SUBJECT: Forwards addl info re NUREG-0737, Item III.D.3.4, "Control Room Habitability Requirements," per 830106 request. Design changes made & justification provided for unsubstantial backfit items, per 830307 ltr.

Re: Turkey Point Units 3 & 4
Docket Nos. 50-250 & 50-251
Post TMI Requirements
Control Room Habitability
NUREG-0737 Item III.D.3.4

Re: Turkey Point Units 3 & 4
Post TMI Requirements
Control Room Habitability
NUREG-0737 Item III.D.3.4

Figure 1
SIMPLIFIED
FLOW DIAGRAM OF
TURKEY POINT CONTROL
ROOM HVAC

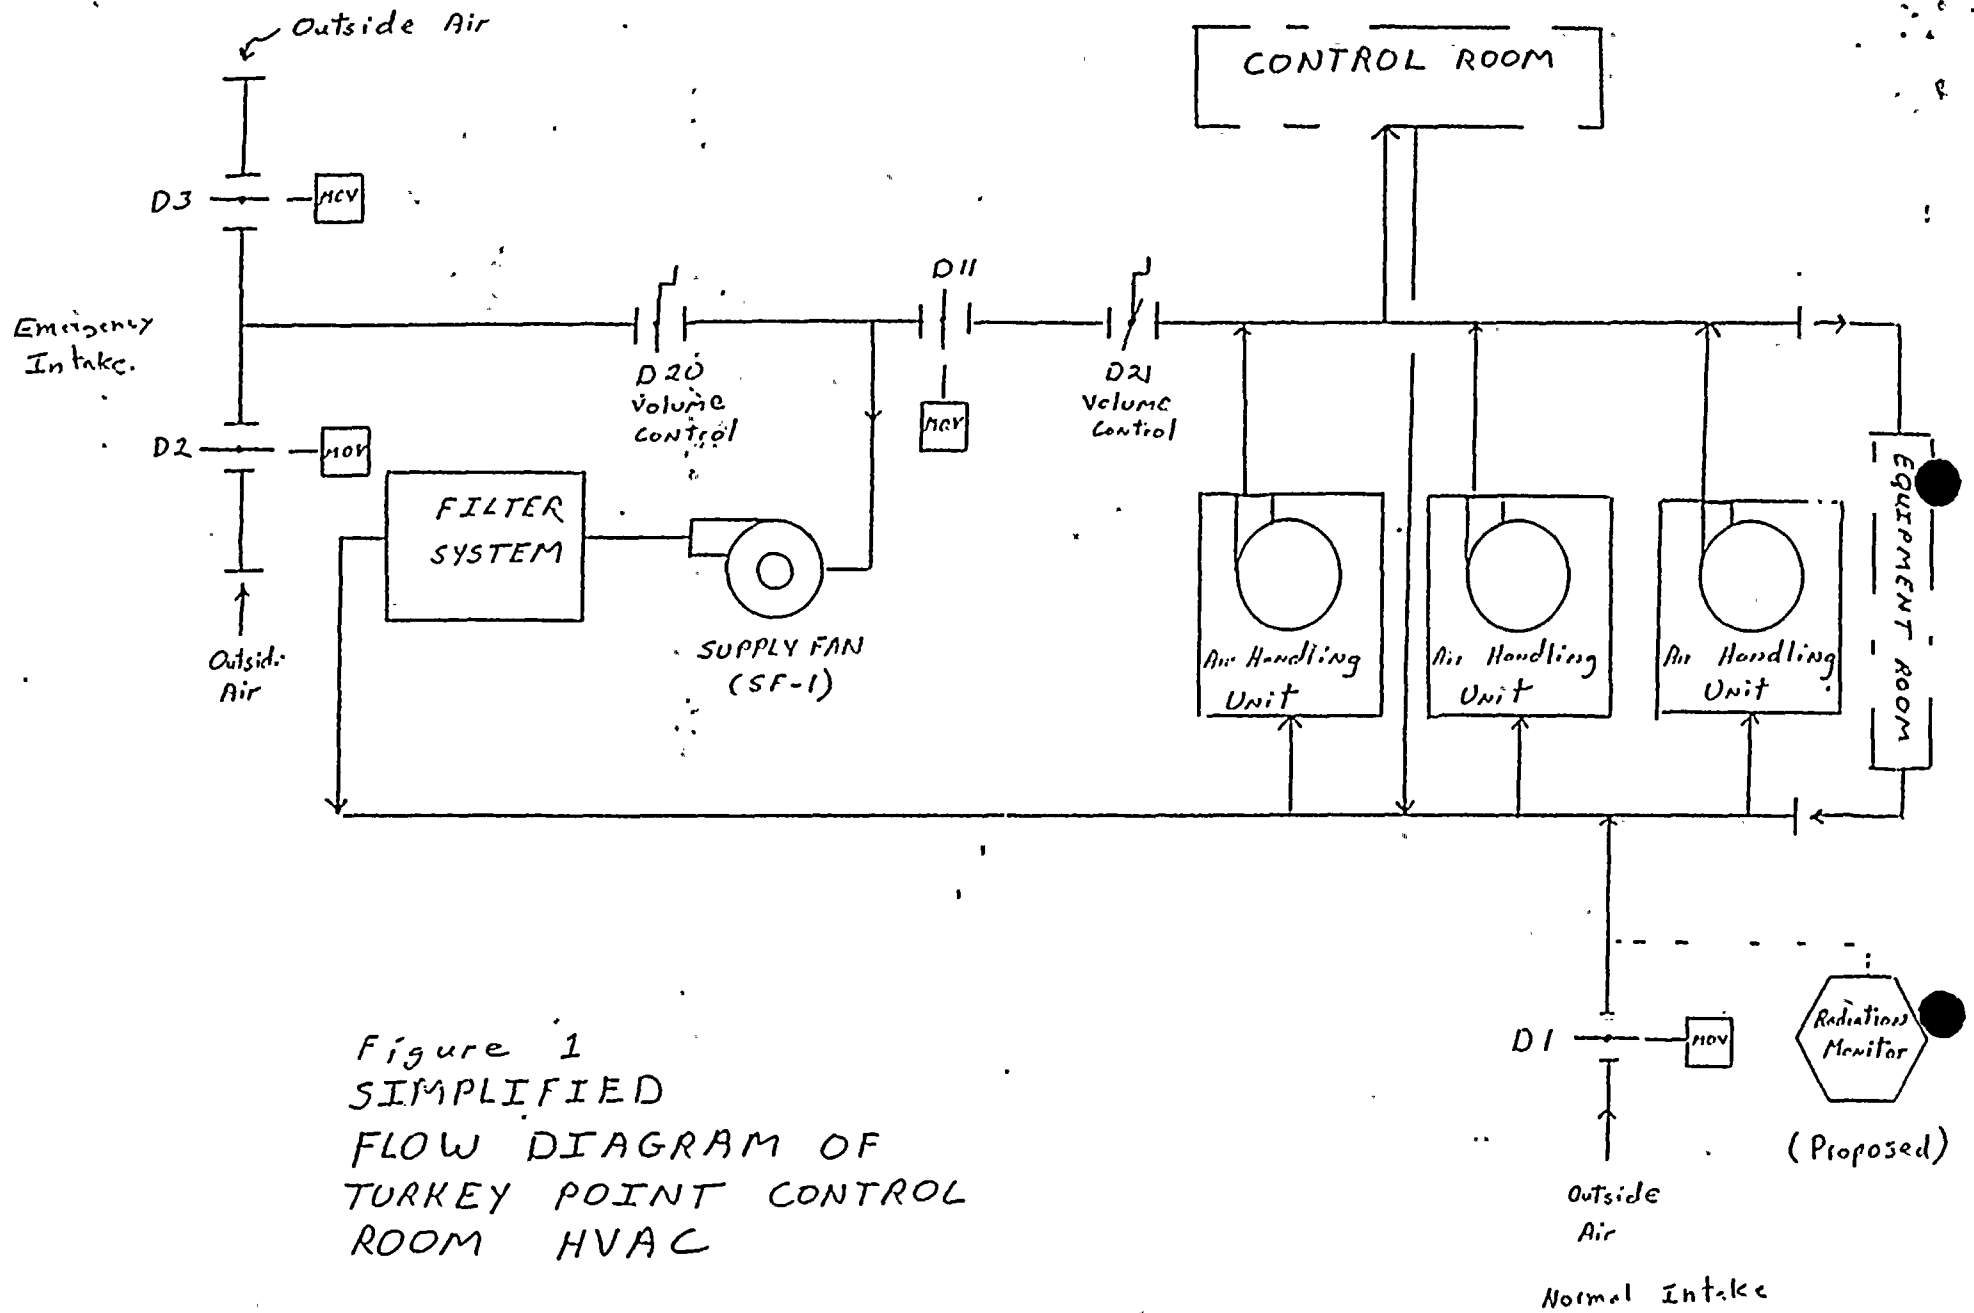
"The control room habitability systems, as engineered safety features, must be capable of performing their safety-related function given the failure of any single active component. It appears, based on the information provided, that the failure of any one of the following active components could result in the loss of the required ventilation system functions:

- a) normal intake isolation damper, D-1
- b) emergency supply fan, SF-1
- c) volume control damper, D-20

In addition, it would be necessary to close volume control damper D-20, if either emergency intake damper D-2 and D-3 were unable to close when isolation and recirculation were demanded. The July 22, 1982, response refers to D-20 as "fixed".

Provide justification that the failure of any one of the active components identified above will not result in the loss of the required ventilation system safety functions or provide proposed design modifications".

"To comply with GDC-19, the staff requires radiation monitors in the normal air intake to initiate isolation of that intake upon detecting radiation well above background and for radiation monitors in the emergency intakes to permit operators to minimize control room doses in the event of an accident.

Provide additional justification or a commitment to install radiation monitors in the normal and emergency air intakes".

Damper D-20 is a fixed position, volume control damper that performs no active function once it is positioned during initial HVAC balance. In order to maintain operator exposures below the requirements of GDC-19 this damper is adjusted to provide a predetermined filtered emergency air intake following an accident. It does not serve an isolation function since filtered intake is provided to remain within the dose limits of GDC-19. On an isolation signal dampers D-2 and D-3 open to provide emergency intake air and thus D-20 is not needed as a redundant isolation damper. See Figure 1.

FPL proposes to install a radiation monitor in the normal air intake that will automatically isolate and pressurize the control room through the filtered emergency intake. As discussed above the licensing criteria to which Turkey Point was licensed does not require single failure criteria be applied to the Control Room HVAC. Therefore, only a single reliable radiation monitor and instrument channel will be used in the design. This is considered adequate since the operator still has several other local control room indications of a radiological accident and is able to take manual actions to protect the control room atmosphere if necessary.

FPL does not intend to install radiation monitors in the emergency air intakes. The basis for the regulatory guidance to install these detectors is embodied in the preliminary review of the Turkey Point Control Room Habitability Study conducted by Battelle Pacific Northwest Laboratories (Reference (c)). The review recommended that ". . . airborne radiation monitors need to be installed in each of the emergency air intakes so that the operator can readily identify which air intake can be utilized without compromising the habitability of the control room".

This statement implies a misunderstanding of the operation of the control room HVAC system. The following is a description of the operation of this equipment. (See Figure 1 for details).

Upon receipt of an isolation signal (containment Phase A isolation, high radiation at plant stack, or normal HVAC intake high radiation) the control room HVAC will automatically isolate the normal intakes and exhausts, open the emergency intakes, and line up and start the emergency supply fan (SF-1). This provides a filtered intake that is used to pressurize the control room. Additionally, some of the recirculated control room atmosphere is routed through the filters for purification.

Damper D-20 is a fixed volume control damper adjusted to provide a predetermined flow (250 cfm) of outside air to the filter. This flow is required to maintain control room pressure to prevent infiltration of unfiltered air. Damper D-21 is also a fixed volume control damper adjusted to provide a constant recirculated purification flow (750 cfm). Neither of these dampers is positioned after the initial ventilation system balance.

The operation of the emergency air intake during the Maximum Hypothetical Accidental (MHA) is not optional. The control room atmosphere is maintained in a safe condition by operation of a filtered intake. If the emergency air intake is not utilized, then unfiltered bypass leakage will occur which may create a potentially hazardous condition. Our radiation analysis performed for the Control Room Habitability Study based on the MHA showed that doses would be within GDC-19 limits only through the use of the emergency air intake and it is our position that the emergency intake be used. There is no total recirculation mode for Turkey Point.

Apparently Battelle's concern about radiation monitors in the emergency intake originates from the assumption that the operator should have information available to indicate which emergency intake is supplying more contaminants so that isolation of that intake can be initiated. From a meteorological viewpoint, there is no significance as to which emergency intake is open since both draw

from approximately the same atmospheric location. Therefore, the radiation monitors in the two emergency intake lines would not provide the operator with meaningful information from which to perform any isolation function.

In Reference (f) the NRC expressed the position that emergency intake radiation monitors provide information for the operators to minimize their doses and information useful for responding to accidents. As discussed above no operator action after Control Room isolation and pressurization is necessary to further reduce exposure.
